AIR RESOURCES BOARD

Executive Order G-70-10-A

Relating to the Modification of the Certification
of the Vapor Recovery System for Delivery
Tanks Equipped for Bottom Loading

EXHIBIT I
 EXECUTIVE ORDER G-70-10-A
 VAPOR RECOVERY SYSTEM FOR
 DELIVERY TANKS EQUIPPED
 FOR BOTTOM LOADING

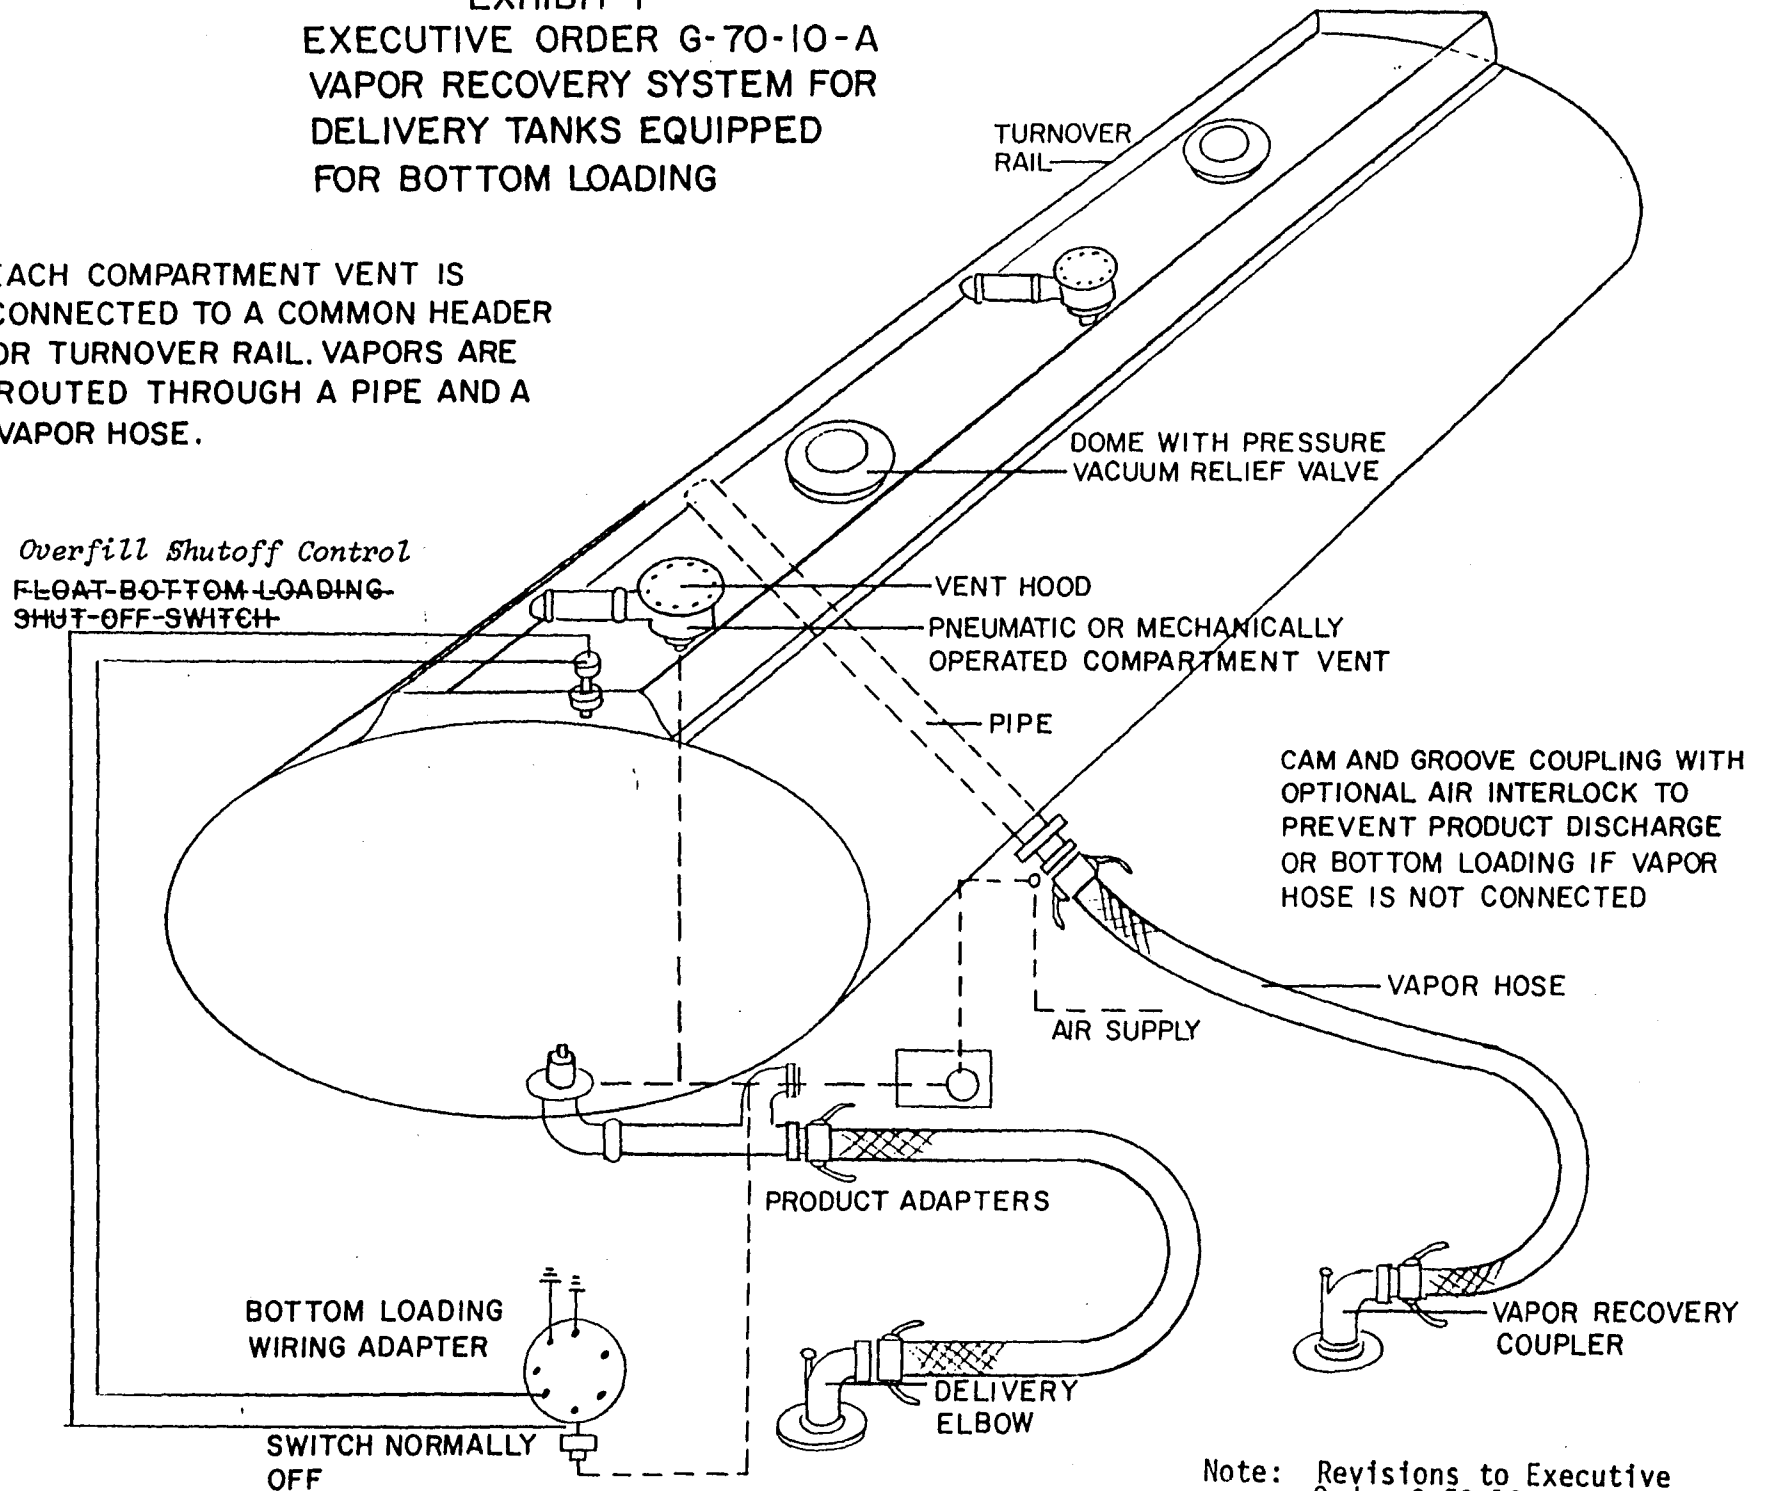
NOTE: EACH COMPARTMENT VENT IS
 CONNECTED TO A COMMON HEADER
 OR TURNOVER RAIL. VAPORS ARE
 ROUTED THROUGH A PIPE AND A
 VAPOR HOSE.

Note: Revisions to Executive Order G-70-10 noted in italics
